Dinawan Wind Farm

Addendum Traffic Impact Assessment

Prepared for Spark Renewables Pty Ltd

Table 1.1 Response to comments from Transport for NSW (superseded by Appendix G of Amendment Report #2)

DRG. #: EMM - C02

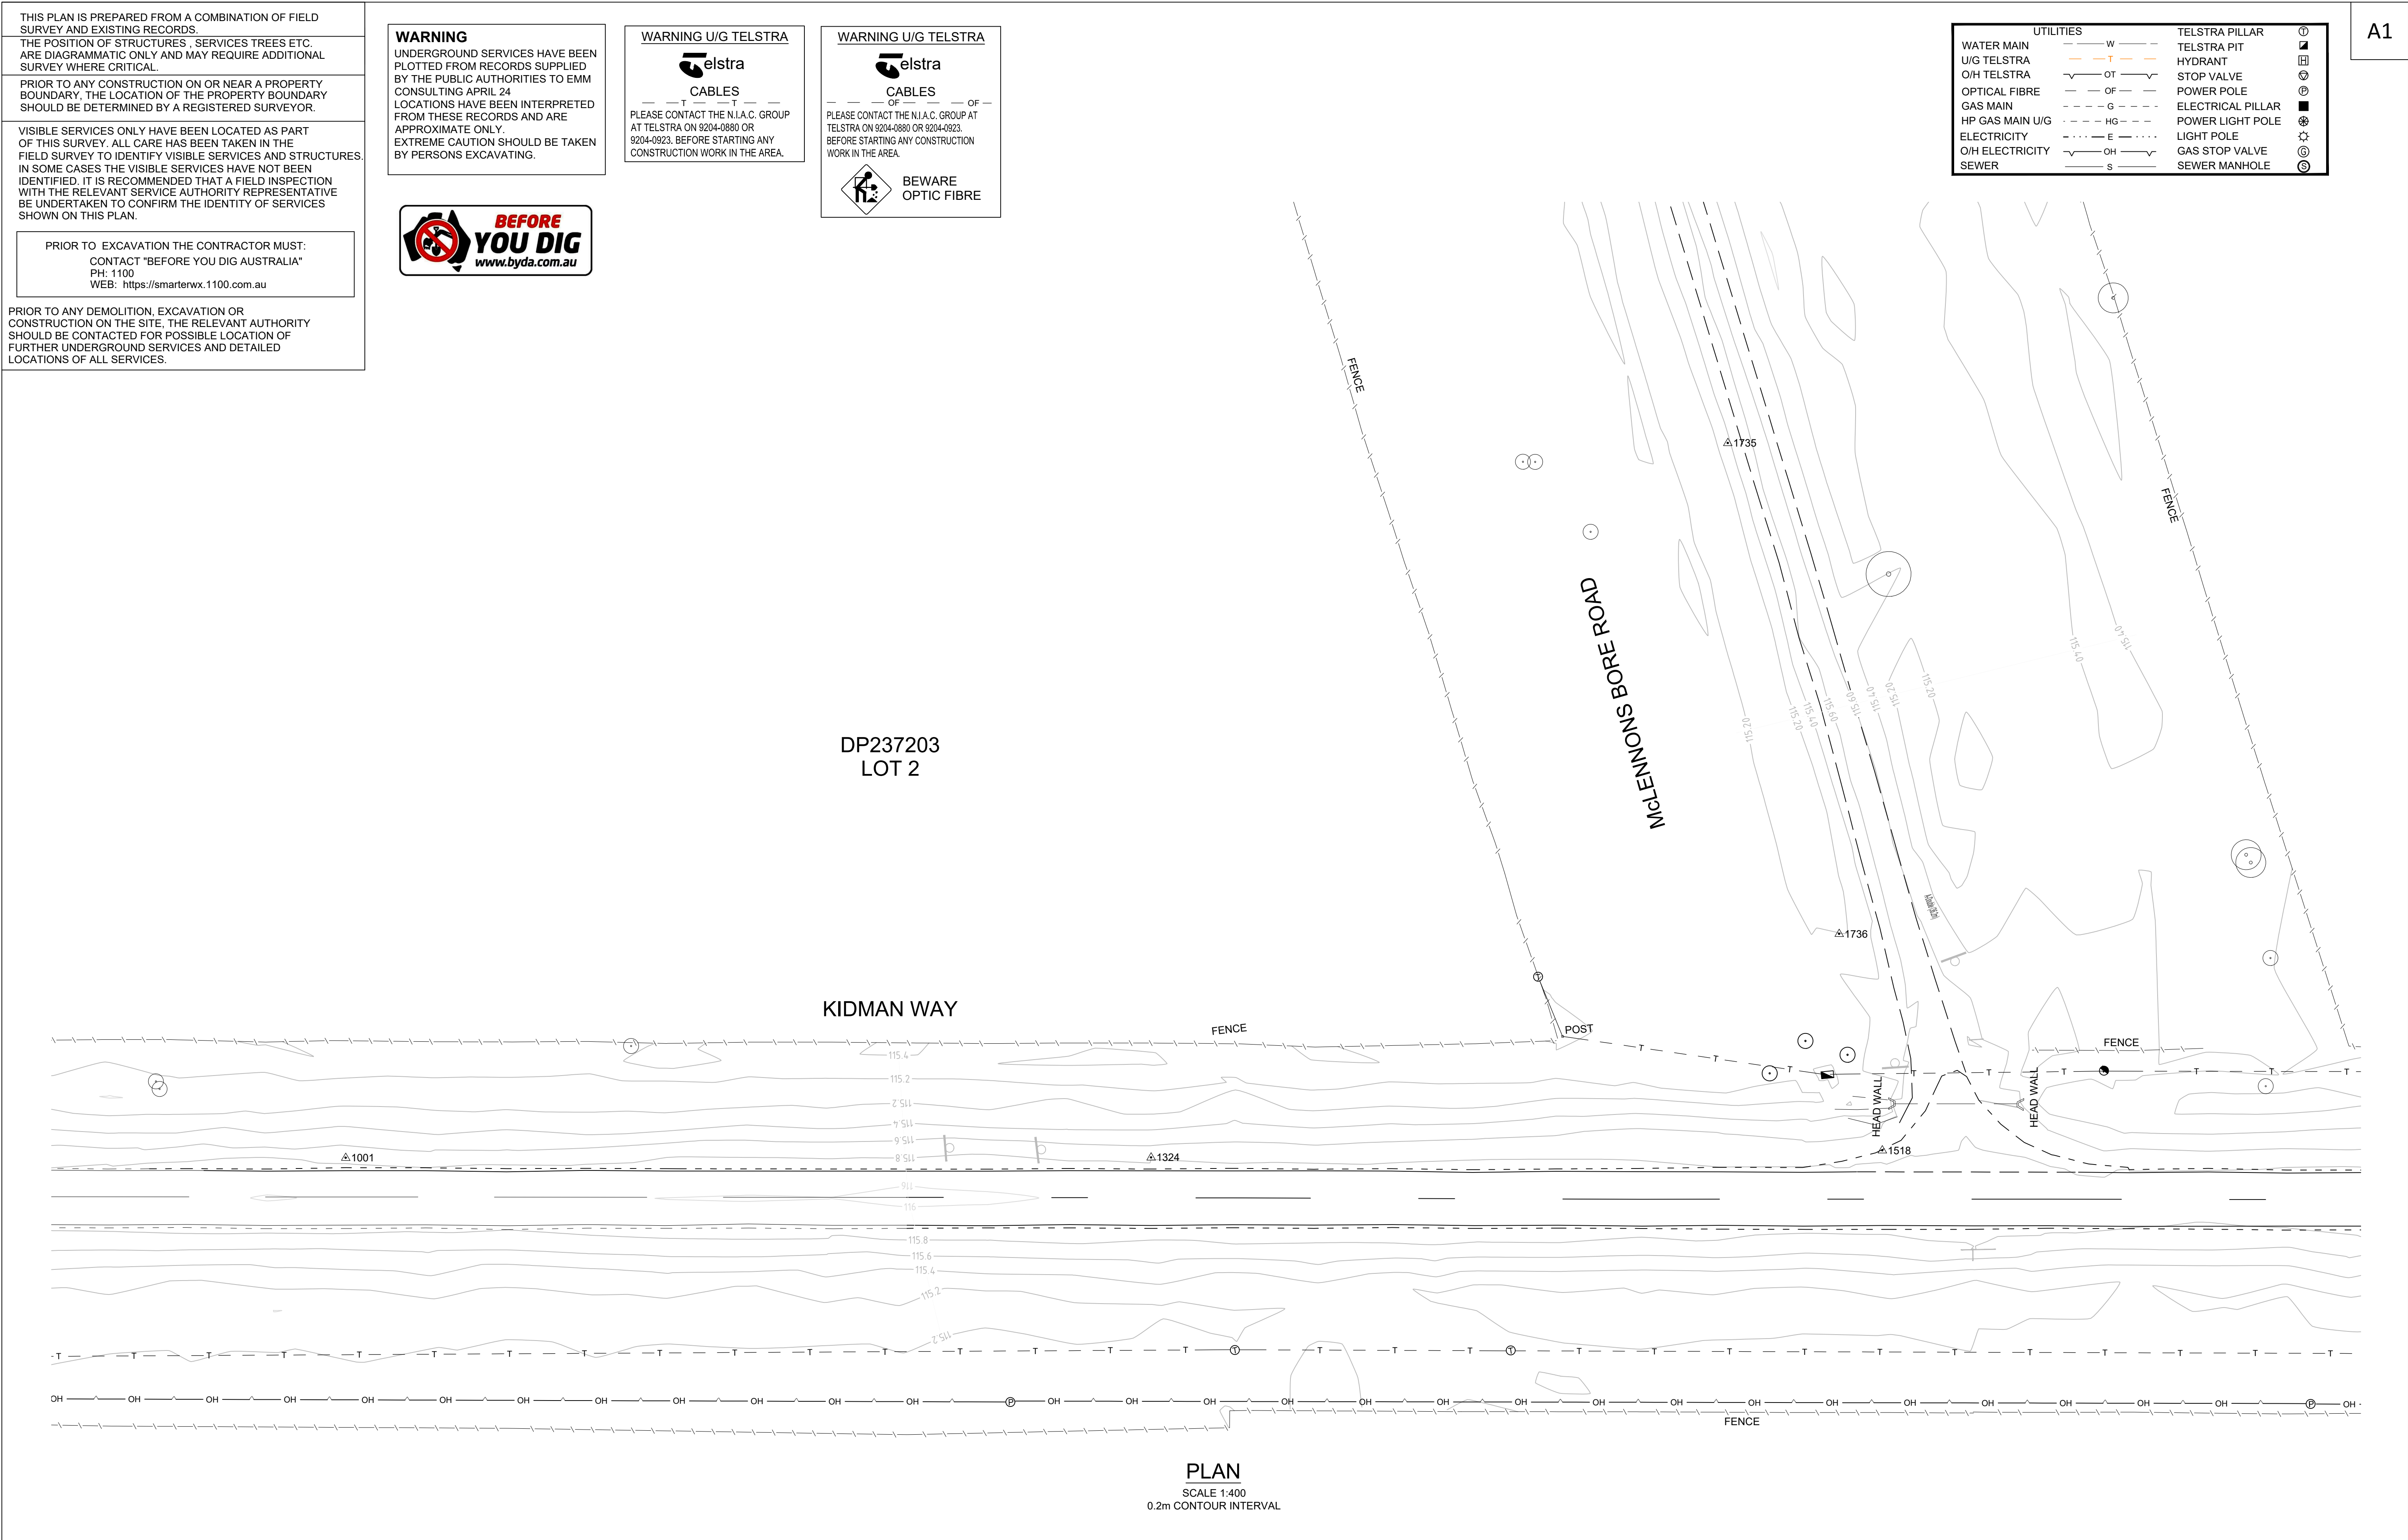
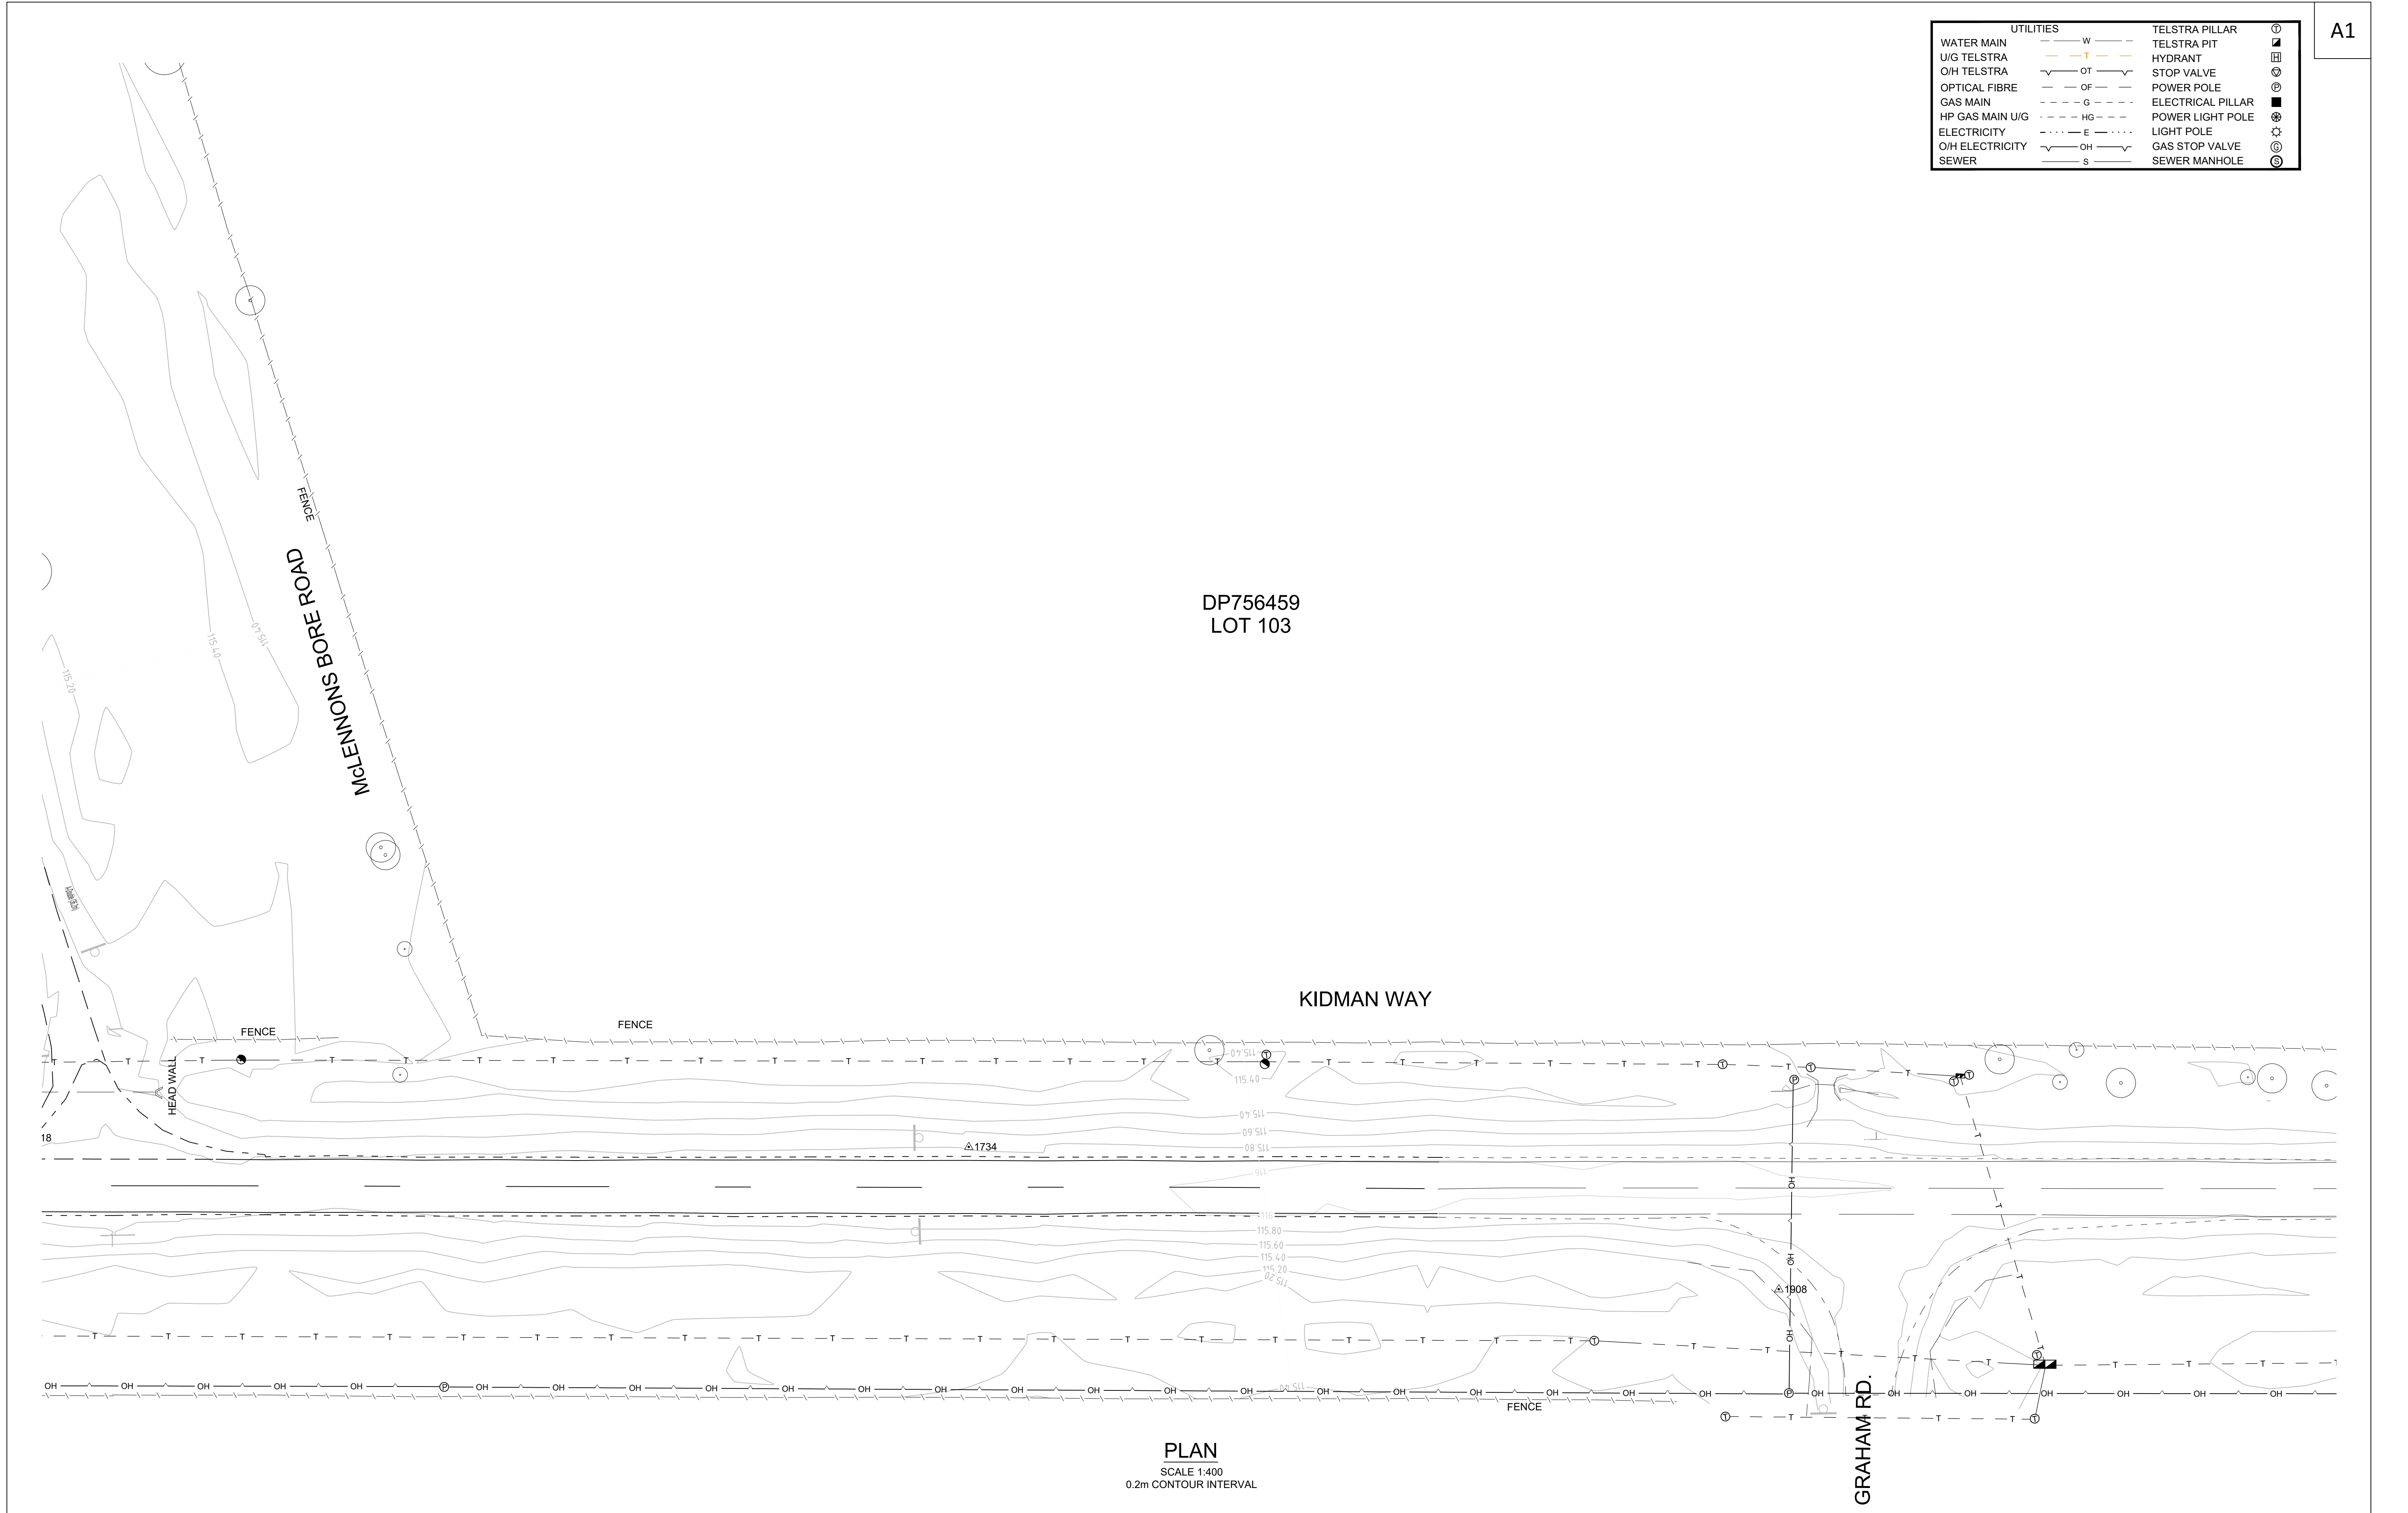
Item no.	TfNSW comment	EMM response
Previous point 2 from TfNSW EIS response: Design requirements for McLennons Bore Road/Kidman Way Strategic concept designs are required to be prepared for the proposed accesses to the Kidman Way, McLennons Bore Road/Kidman Way, and Cadell Road/Kidman Way intersections.	TfNSW notes that the RtS included the submission of the strategic concept designs for McLennons Bore Road/Kidman Way. TfNSW has reviewed the strategic concept designs as part of the RtS review and advises that the strategic concept designs are to be revised to address the following points: a) The design for the left turn treatment incorporates a combination of an Auxiliary Left Turn (AUL), a high-speed entry curve, and a short merge lane, which does not align with Austroads. An updated intersection design is required to conform to a standardised treatment type, either an AUL or a Channelised Left Turn (CHL), along with a justification for the selection of the CHL if this is the chosen option. b) The designs must be revised to reflect the design speed, which is defined as the posted speed limit plus 10 km/h. c) The current approach and departure design speeds exceed Austroads design speeds, resulting in potential issues with vehicles merging at different speeds. The designs need to be revised accordingly to align with the Austroads design speeds for approach and departures. d) The chevron markings and the splitter island require correction, as the mainline chevron is currently oriented in the wrong direction. e) In addition to the above, the following design revisions are required: i) Specify the radius of the curve on McLennons Bore Road, as it approaches the intersection, ii) The CHR's X value is to align with Austroads requirements, which is typically 10 to 15 meters.	A revised strategic concept design can be found in Section A.1 of Annexure A. a) A standard channelised left turn (CHL), where left turning vehicles from Kidman Way are required to give way to right turning vehicles from Kidman Way, has been chosen. This allows the right turn treatment from Kidman Way to be kept as a shortened channelised right turn (CHR(s)), thereby reducing the upgrade area required on the north approach and avoiding impacts to neighbouring intersections (i.e. Kidman Way and Graham Road). b) The designs reflect the design speed of 110 km/h, which is 10 km/h above the posted speed limit of 100 km/h. c) The new design avoids merging issues, so this comment no longer needs to be addressed. d) The chevron markings and splitter island have been modified to be correctly oriented. e) i) The radius of the curve on McLennons Bore Road approaching the intersection has been specified. ii) While Austroads states that the CHR(s) X value is typically 10–15 m, the actual X value is determined by swept paths. Swept paths show that the design vehicle can stop at the end of the BL2 line on the correct side of the road before making the right turn from Kidman Way into McLennons Bore Road. Further increasing the X value means that vehicles turning right from Kidman Way may stop further away from the intersection while waiting to turn right, which increases the risk of conflicts with vehicles turning from McLennons Bore Road. The strategic concept design has subsequently been updated to address comments from TfNSW (12 May 2026), including updating the WT value to 3.5 m, and presenting the 0.5m verge on the plan as requested.

Item no.	TfNSW comment	EMM response
RFI-1 Strategic concept design revision requirements for the Kidman Way east and west access points	TfNSW requests the following information regarding the east and west access points to the Kidman Way, which have been included as part of the project revisions and within the RTS submission. The Kidman Way east and west access points did not form part of the EIS package for the Dinawan Wind Farm. Strategic concept design revision requirements for the Kidman Way east and west access points. The strategic concept designs for the Kidman Way east and west access points are to be revised to address the three points raised below. Provide a TB1 (150 mm wide broken line) at both the East and West Access. Chevron line marking in the painted medians appears to be backwards. The angle of the chevrons should align with the direction of the approaching vehicle. The CHR(S) T values is 31 m, the T value, is to be revised to align with Austroads requirements (refer to Table 7.1 within <i>Austroads Guide to Traffic Management Part 6</i>) which refers to the requirement of a 30 m or 35 m T value (i.e increments of 5 m). Note: If higher order intersection treatments are required then the points raised in points 2, 3 and 4 must be considered as part of any revisions to the strategic concept designs to capture the higher order intersection treatments at this location.	The strategic concept design has been updated (Section A.3 of Annexure A), including: • a TB1 line has been provided on both east and west access intersections • the chevron line markings have been revised • the CHR(s) T values in Table 7.1 of <i>Austroads Guide to Road Design Part 4A</i> are based on a turn lane width of 3 m. As the turn lane width is 3.5 m, the T value needs to be calculated using the formula $T = (0.33 \times (\text{design speed}) \times (\text{width of turning lane}))/3.6$ (as shown below Figure 7.2 of <i>Austroads Guide to Road Design Part 4A</i>). Using a design speed of 110 km/h, the value of T equals 35 m. Therefore, the taper has been updated to be 35 m long.
